# MICHIGAN DEPARTMENT OF ENVIRONMENTAL QUALITY

## INTEROFFICE COMMUNICATION

DATE: July 13, 2007

SUBJECT: Review of 2007 Model of Evergreen System

Figure 1 – Location of downgradient constant-head boundary.

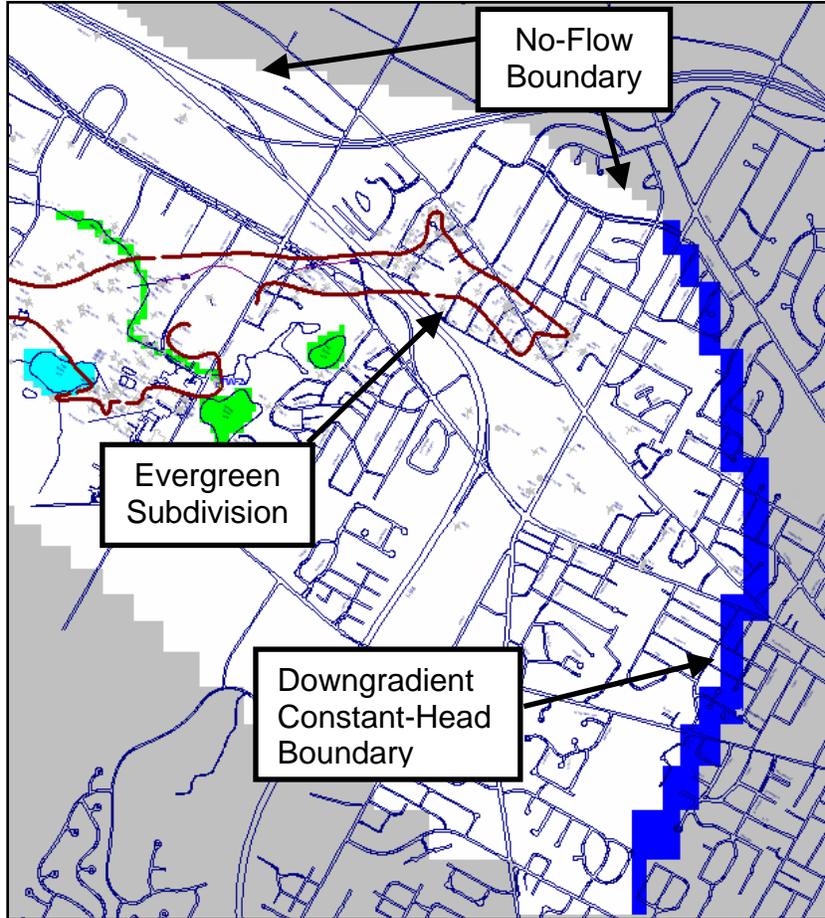
The direction of groundwater flow in the Evergreen Subdivision is based on a limited number of monitoring wells, especially north of Dexter Road. FTC&H has placed a “no-flow” boundary to the north of the Evergreen Subdivision area and a constant-head boundary along the east side of the model (see Figure 1). The no-flow boundary prevents groundwater from moving to the north and forces all groundwater to flow parallel to this boundary from west to east toward the constant-head boundary. It has always been our contention that there is some component of regional groundwater flow to the north that has not been adequately investigated. Regional groundwater flow directions in the glacial drift were inferred from records of residential water wells that have been installed since 1990. The contours of equal hydraulic head and inferred regional groundwater flow directions (black arrows) are shown on Figure 6. Also shown on this figure are the approximate digitized extent of 1,4-Dioxane contamination, the Montgomery Street well, the Huron River, and monitoring wells MW-77 and MW-92. This information appears to show that the PLS site is located on a “hydraulic head high” and that groundwater appears to be moving away from the site to the west-northwest, north and east away from the site. These inferred flow directions are somewhat verified by the depicted migration of site-related contamination to the west-northwest (not shown), toward the north-northeast (Unit D plume), and east (Unit E plume and Montgomery Street well). This indicates that there may be some validity to the interpolated hydraulic-head surface and inferred groundwater flow directions

It is our opinion that the no-flow boundary is not correct, nor is it supported by any field data. The impact of placing the no-flow boundary in this area on simulated flow directions and capture extent must be verified and assessed. In addition, the current constant-head value assignments in this downgradient boundary may be impacted by the elimination of pumping from the Montgomery Street well. Any future model simulations will have to assess the appropriateness of this constant head boundary or its impact on simulation results.

Figure 2 – Simulated calibration residuals for Model Layer 2.

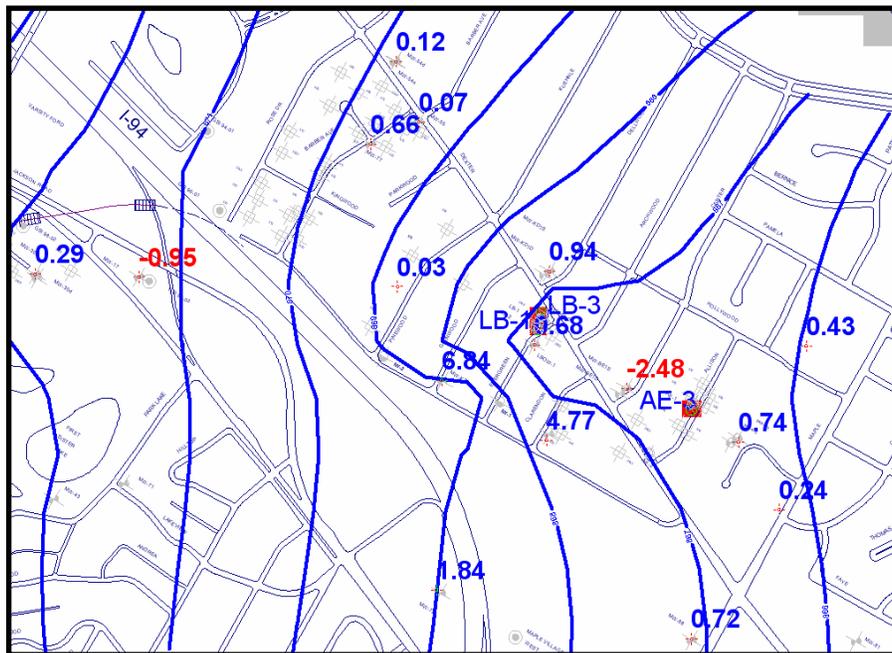
Model simulated hydraulic heads were compared to groundwater level elevations measured in wells open to model layers 2 (Unit D aquifer) and 4 (Unit E aquifer) from the September 2006 sampling event. The model simulated heads and differences between the simulated heads and measured heads (residuals) are shown in Figures 2 and 3. Positive residual values indicate that the measured heads are higher than the model simulated heads. Negative residual values indicate that the measured heads are less than the model

simulated heads. The results show that, with the exception of wells MW-17 (-0.95 feet) and MW-BE1d (-2.48 feet), the model-simulated heads are lower than the measured heads in the Unit D aquifer (layer 2). On the basis of the limited number of hydraulic head measurements used for comparison, it appears that the model-simulated heads are lower than the measured heads in the Unit E aquifer (layer 4). Since there were no simulations or measurement of groundwater level elevations that reflect pre-pumping conditions, it is not apparent whether the model is over-predicting drawdown caused by the Evergreen System pumping or there is a conceptualization problem with model framework, hydraulic properties, or the values used to represent the constant-head boundaries. No other model calibrations, such as simulating the decline in hydraulic heads since 1994, comparing to another set of measured hydraulic heads, or tracking contamination back to source areas to verify simulated groundwater flow directions or model conceptualization were attempted. On the basis of statistics that were calculated using these head residuals, FTC&H determined that the model was "calibrated".

Figure 6 – Direction of Regional Groundwater Flow

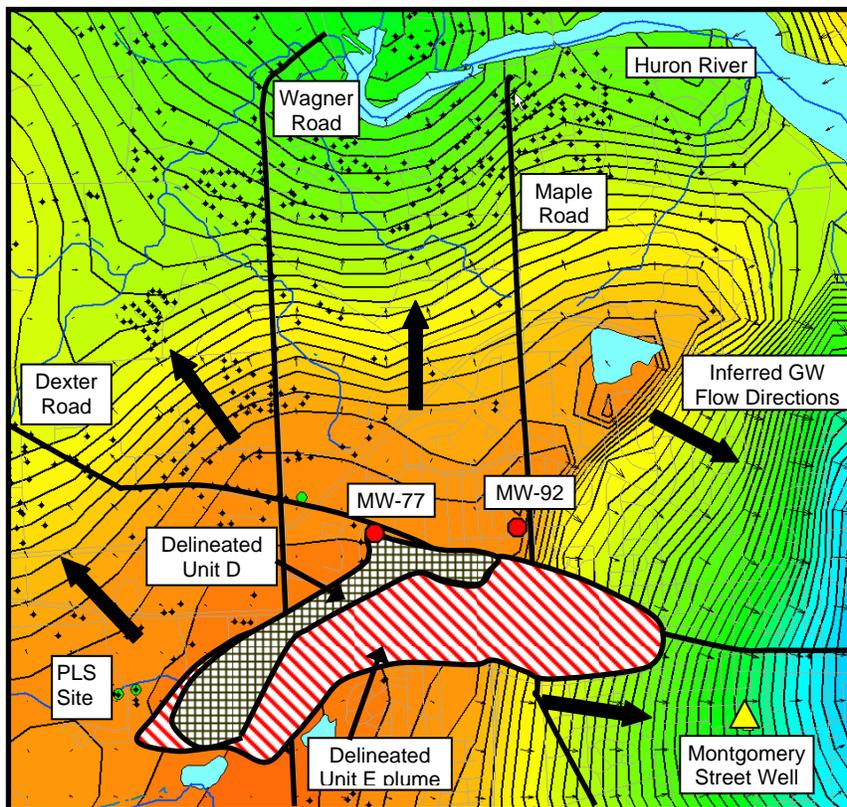
North of Dexter Road, the inferred directions of groundwater flow (see Figure 6) suggests that there may be the possibility of some contaminant migration to the north. However, the verification of groundwater flow and contaminant migration directions north of Dexter Road is incomplete, primarily because so little good-quality data (obtained through vertical aquifer sampling) have been collected in this area. In the model, the placement of the no-flow boundary to the north prevents the model from simulating a northward groundwater flow direction. As a result, the simulated groundwater flow direction near Dexter Road is due east, rather than to the north. This is an artifact of the manner in which the model is constructed that has not been verified by the collection of field data. Additional good-quality data (groundwater levels or chemical analyses) are needed north of Dexter Road to verify whether the west-to-east simulated flow directions or the regional groundwater flow directions to the north that are shown in Figure 6 are correct.

The direction of groundwater flow north of Dexter Road and west of Rose Drive is not known. It may be that groundwater and 1,4-Dioxane contamination are migrating to the north. This may be the reason for the increase in 1,4-Dioxane concentrations at 465 Dupont and MW-77. It is necessary to collect additional groundwater level measurements north of Dexter Road to determine whether groundwater moves to the north or to the east. The design of the Evergreen System, and the orientation of the simulated capture extent, is based on the presumption that the direction of groundwater movement is to the east. If the direction of groundwater flow is to the north-northeast, the simulated groundwater flow directions, and the orientation of the extent of capture are incorrect.

Figure 7 – Distortion of simulated cone of depression in Unit D aquifer (Model Layer 2).

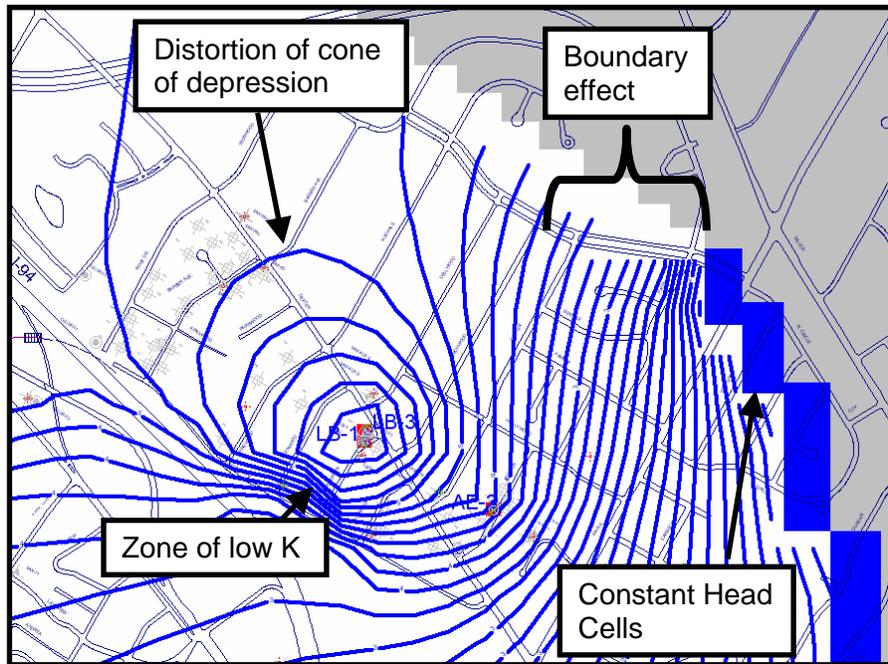
The placement of the no-flow boundary and the downgradient constant-head boundary relatively close to the Evergreen System, besides determining groundwater flow direction in the model, results in a distorted cone of depression that will distort the simulated capture extent. Figure 7 shows the simulated drawdown for model layer two (Unit D aquifer) assuming a pumping rate of 202 gpm from the Evergreen System wells. The combined impact that these boundaries, the inferred zone of low hydraulic conductivity to the south of LB-1 and LB-3, and the lack of connection between the Unit D and Unit E aquifers (model layer three was assumed to be continuous throughout this area) have had on the simulated extent of capture should have been assessed.

Figure 8 – Reverse Particle-Tracking in Model Layer 2, Evergreen System pumping 202 gpm.

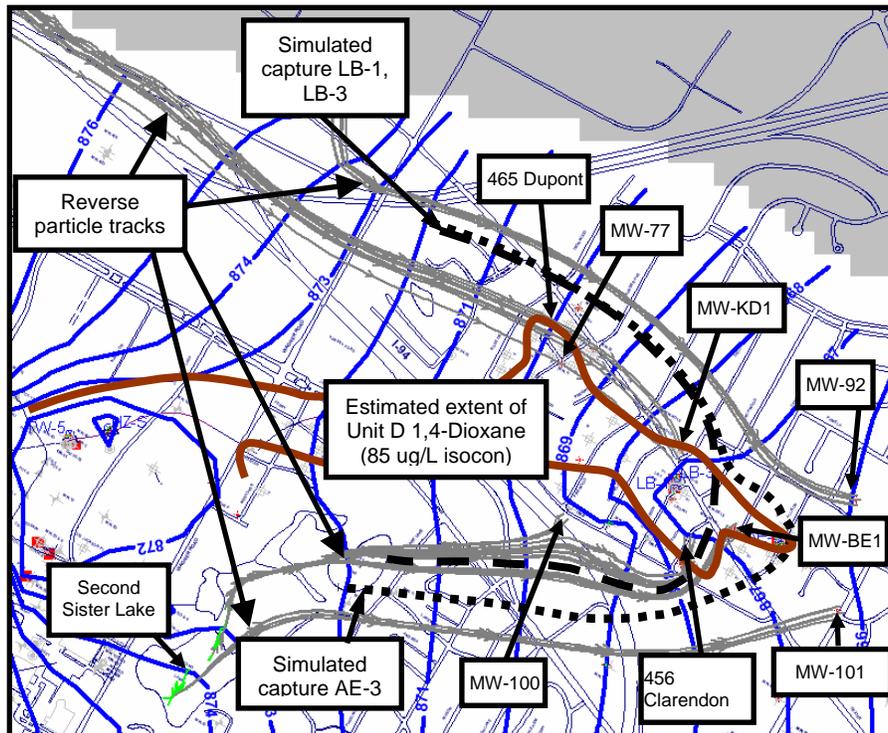
A reverse particle-tracking analysis was performed using the 2007 Model by placing particles around several monitoring wells at which the concentrations of 1,4-Dioxane have been increasing or are near the edge of the simulated capture extent. The objective is to assess the possible origin of the contaminants that have been detected in these Unit D aquifer monitoring wells. Figure 8 shows the reverse particle tracking analysis with the Evergreen System wells pumping at a combined rate of 202 gpm (LB-1 = 90 gpm, LB-3 = 80 gpm, and AE-3 = 32 gpm). Particles were released around wells MW-77, MW-92, MW-100, MW-101, MW-KD1, MW-BE1, 456 Clarendon, and 465 Dupont. These simulations, if accurate, show that contaminants and groundwater found in the wells at 465 Dupont, MW-77, MW-KD1 and MW-92 would have migrated entirely within the Unit D aquifer from the west-northwest, from an area that is north and west of the delineated extent of the Unit D 1,4-Dioxane contamination (north of the intersection of Wagner Road and M-14). The reverse particle tracking analysis also shows that the contaminants and groundwater found at MW-100, 456 Clarendon, MW-BE1, would have migrated entirely within the Unit D aquifer from an area southwest of I-94 and MW-101. This area is south of the delineated southern extent of the Unit D aquifer plume.

The simulated capture extent and delineated extent of Unit D 1,4-Dioxane contamination are also shown on Figure 8. Wells MW-77, MW-100, MW-KD1, MW-BE1, 456 Clarendon, and 465 Dupont are all located within the simulated extent of capture. Only wells MW-92 and MW-101 are found outside the simulated capture extent of the Evergreen System. It's important to point out that the particles representing contaminant and groundwater flow to these wells do not enter the Unit E aquifer at upgradient locations, indicating no upwelling of groundwater from this lower aquifer to the Unit D aquifer. The model simulations would indicate that all of this contaminated groundwater comes from the Unit D aquifer, some of it coming from areas where 1,4-Dioxane concentrations have not been detected in the Unit D aquifer or there has been no investigation of possible 1,4-Dioxane contamination.
